Office Action Summary	Application No. 10/723,487	Applicant(s) MCCUSKEY ET AL.	
	Examiner Gwendolyn Baxter	Art Unit 3632

This is the third Office of application serial number 10/723,487, Weapon Caddy, filed November 26, 2003.

5,778,589

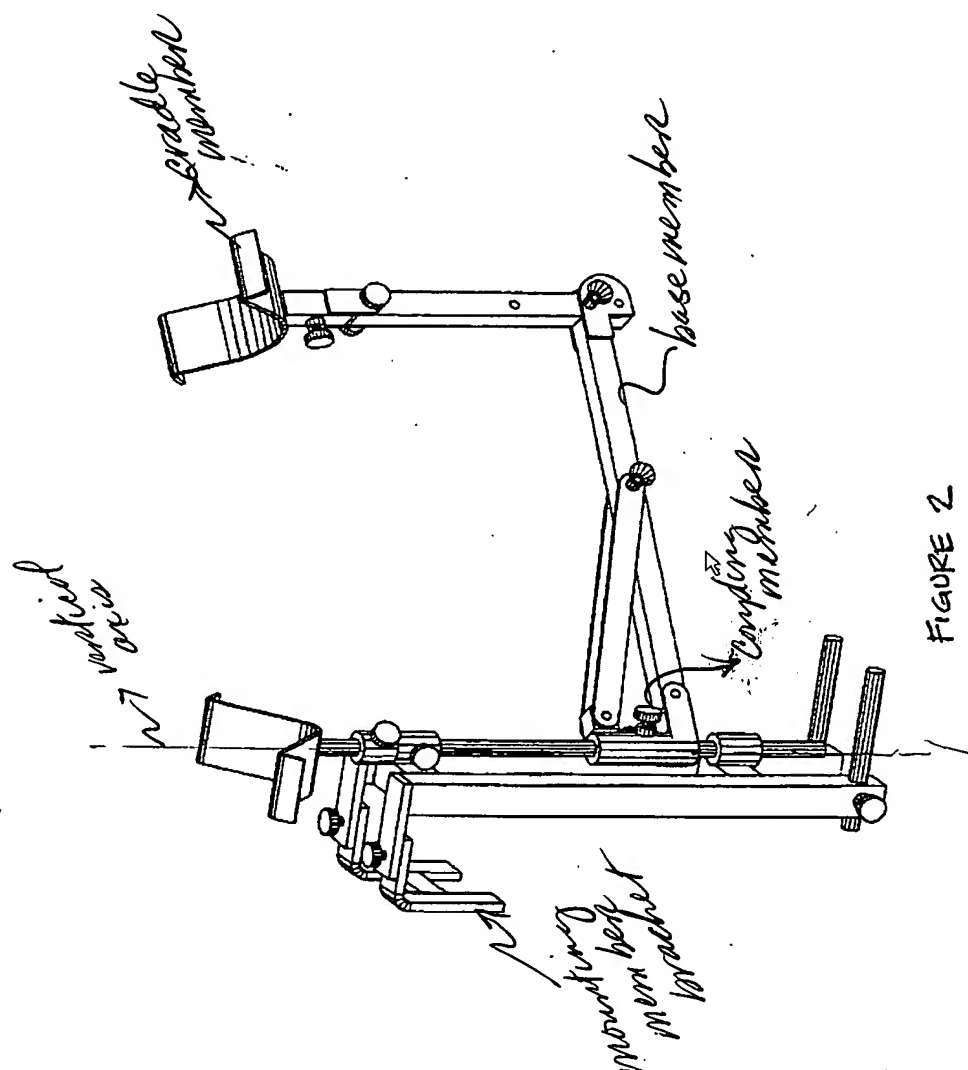
Claims 1 and 7 are rejected under 35 U.S.C. 102(b) as being anticipated by U.S. Patent No. 5,778,589 to Teague. The present invention reads on Teague as follows: Teague teaches a caddy comprising a mounting bracket (20), a base member (30), and a cradle member (45). The mounting bracket is structured and arranged for mounting on a support structure (11). The base member is slidably mounted on the mounting bracket. A coupling (40) is between the mounting bracket and the base member, which permits both sliding and rotating movement between the mounting bracket and the base member at a single point of connection between the mounting bracket and base member. The cradle member is mounted on the base member and structured and

arranged for supporting the weapon. The base member is rotatable around a substantially vertical axis when the mounting bracket is mounted on the support structure. See below.
